MAJOR PROJECT ASSESSMENT:

CASUARINA TOWN CENTRE

Director-General's
Environmental Assessment Report
Section 75I of the
Environmental Planning and Assessment Act 1979

August 2009

Figure 14: Proposed Town Centre Road Network (source: Preferred Project Report)

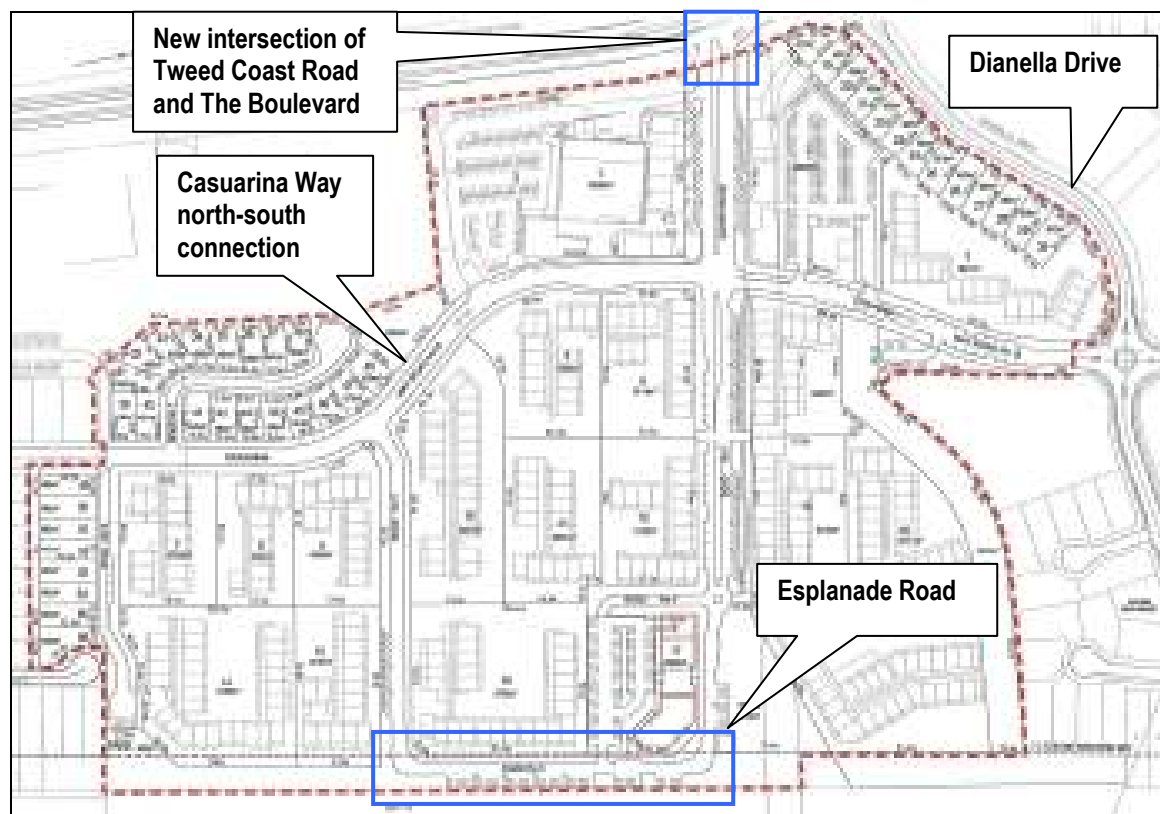
The esplanade road extending along only a portion of the foreshore is not supported. An esplanade road extending the entire length of the section of foreshore within the site should be provided, as shown on the earlier Concept Master Plans. The extended road maximises public benefit through increased access to Casuarina Beach.

The proposal includes the provision of a 195m long esplanade road, which equates to approximately one-third of the site's foreshore frontage. Council raised concern that the esplanade road does not extend for the full length of the site, as was envisaged by the Kings Beach Development Plan (as approved by the Land and Environment Court). Council requested that the esplanade road be extended along the entire foreshore frontage to provide the public with more car parking options and subsequently enhance access to Casuarina Beach.

The Department considers that the current length of the esplanade provides a satisfactory level of access for vehicles to the foreshore. It is noted that as part of the PPR that the number of car parking spaces along the esplanade road has increased by providing 90 degree angled parking along the entire eastern side of the road, increasing the ability of foreshore users to park close to the beach. The remaining area along the foreshore has already been, or will be as a result of the proposal, dedicated to Council as public open space. The provision of this public open space (which will also facilitate access to the beach, as Council desires) is preferable to the extension of the road and will provide a safer pedestrian and cyclist environment in this foreshore area. As a result, the Department recommends the length of the esplanade road as proposed.

Figure 15: Photomontage of Screening within the Open Space Corridor (source: Preferred Project Report)

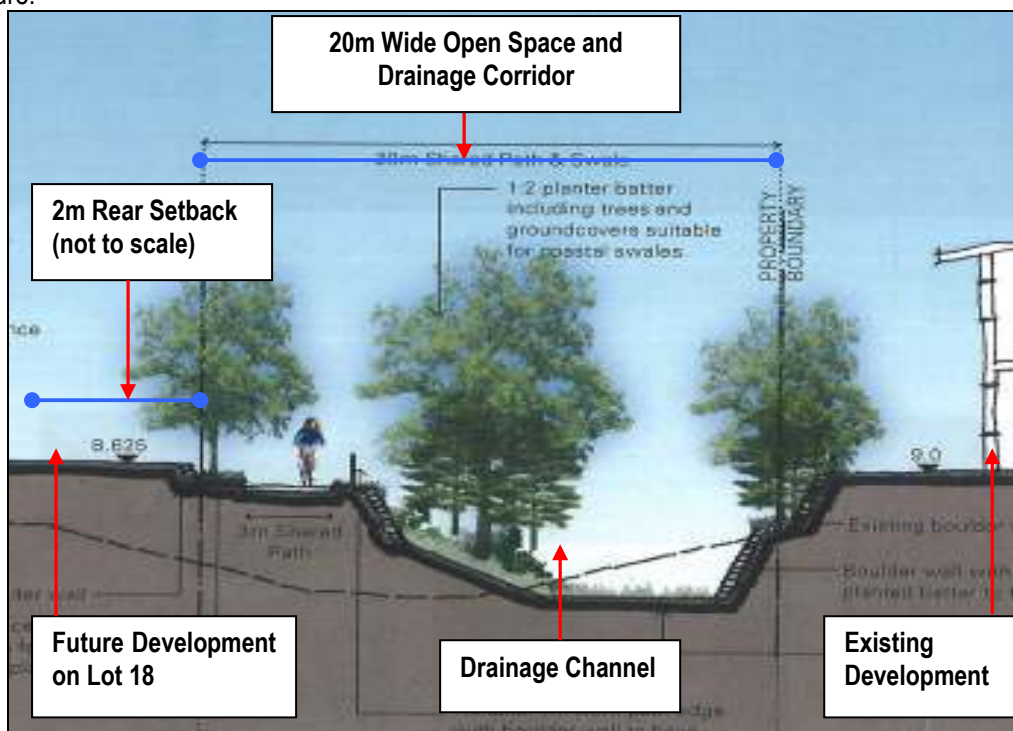
- Filling the east-west drainage easement only to a width of 20m to be used as open space corridor containing a 3m wide pedestrian cycleway on the southern side of the easement, with a 17m wide drainage channel on the northern side, see **Figure 15** below.

Council in their submission on the EA considered the proposal to fill the drainage easement and provide an alternative piped drainage system as an unacceptable method of dealing with stormwater flows. The reasoning behind Council's submission included;

- 1) Piped drainage systems have capacity constraints and are prone to blockages that do not occur in open drainage systems of the kind currently provided by the easement; and
- 2) The easement provides filtration and treatment of stormwater flows by using the infiltration properties of the underlying sand, subsequently reducing downstream impacts of the development. Council concluded that a piped drainage system could not provide the same level of stormwater treatment.

The infiltration performance of the existing open drainage easement will not be detrimentally impacted upon by reducing the easement width. The proponent advises that the 20m wide east-west open drainage easement will provide capacity for 1,200m² of infiltration area. The entire base of the easement is to contain underlying sand and grass for infiltration purposes, and will treat drainage and stormwater flows before being directed to the

The Department considers the proposal to fill the east-west drainage easement and provide a 20m wide open space corridor with a realigned pedestrian cycleway as a favourable development outcome and one which provides a significant public benefit. This is based on that fact that;

Figure 25: Closure of Dianella Drive and new intersection of Tweed Coast Road and Boulevard Roads
(source: Preferred Project Report)

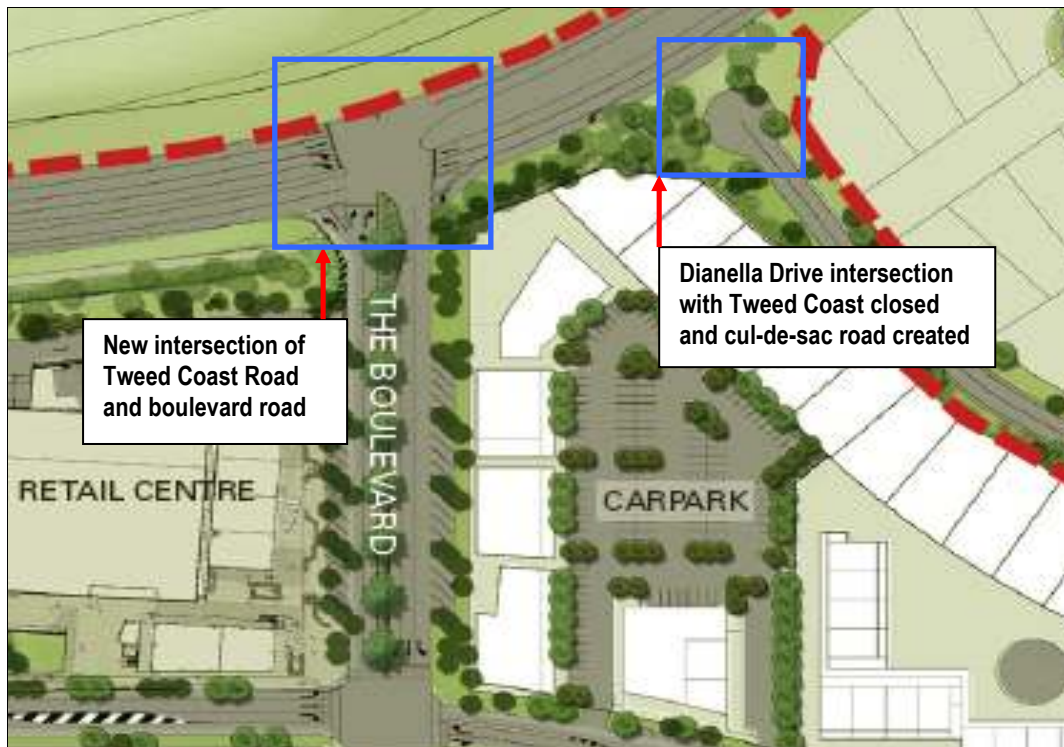
The proposal seeks to close the existing intersection of Dianella Drive and Tweed Coast Road. The western end of Dianella Drive will be altered to form a cul-de-sac road extending off Casuarina Way (see **Figure 25** below). Dianella Drive will continue to service the adjacent residential catchment, including proposed stage 1 low density residential lots 19 to 30. To replace the role of Dianella Drive, a new connection to Tweed Coast Road will be created approximately 80 metres to the south (the Boulevard road). Council recommended a 10m distance be maintained between the Dianella Drive cul-de-sac and Tweed Coast Road carriageway in order to provide a services corridor between any future road structures. This requirement has been conditioned.

Figure 26: Traffic Circulation in the Retail Centre Car Park (Source: Preferred Project Report)

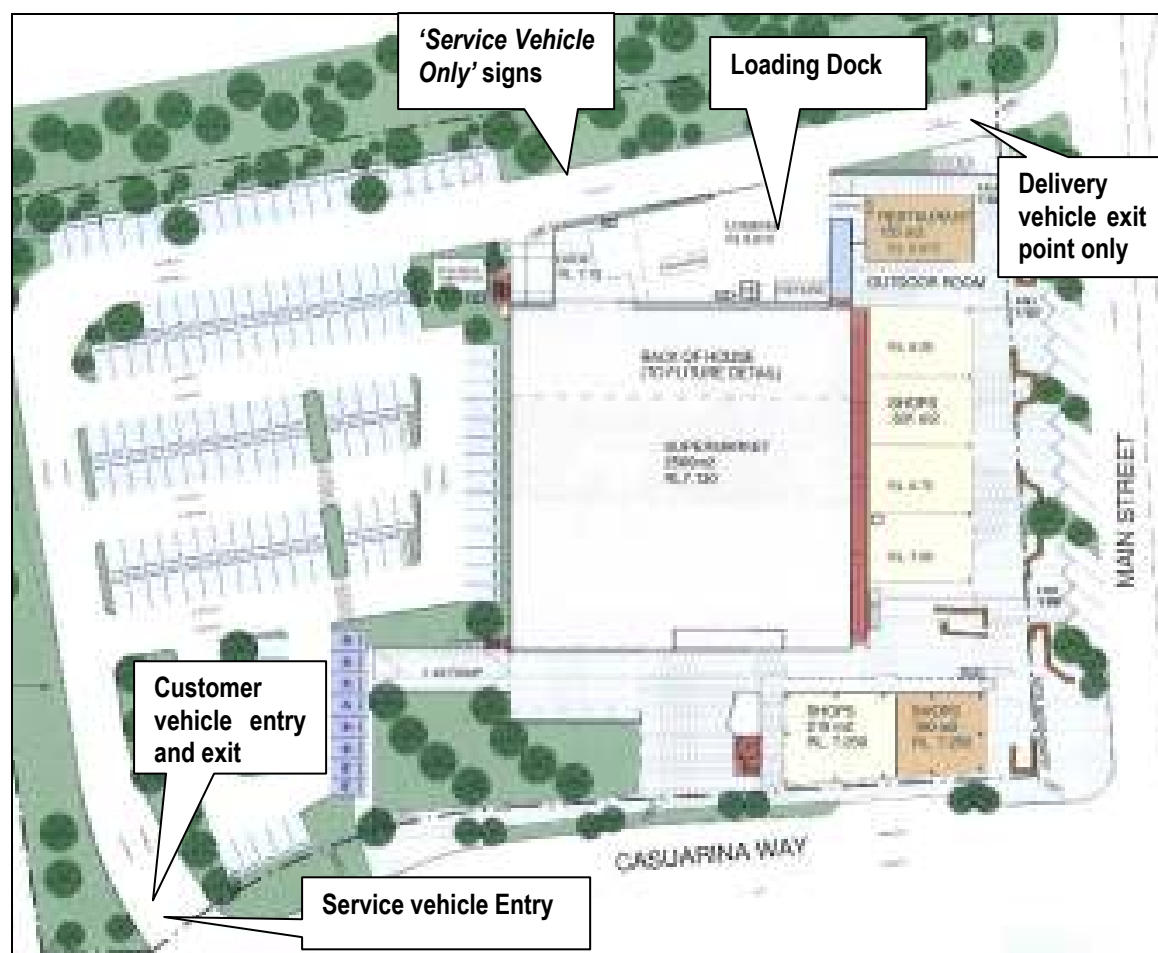
The retail centre proposes that delivery vehicles to travel through the customer car parking area to obtain access to the loading dock on the western side of the retail centre. The exit point for delivery vehicles will be directly to the proposed Boulevard road. Customer vehicles will be prohibited from using this exit from the retail centre and will be required to exit onto Casuarina Way (refer to **Figure 26** below).

The Department considers that the optimal outcome for the retail centre would be the complete separation of delivery vehicles from customer traffic. However, following the exhibition period, the proponent amended the car parking layout in order to reduce potential conflicts between delivery and customer vehicles. The delivery vehicle route now only conflicts with a limited number of customer car parking spaces furthest away from the retail centre at the southern end of the car park (and therefore least likely to be used).

Overall, the Department considers that the circulation of delivery vehicles within the retail centre car park is an acceptable response and reduces any potential conflicts between deliveries and customer traffic.
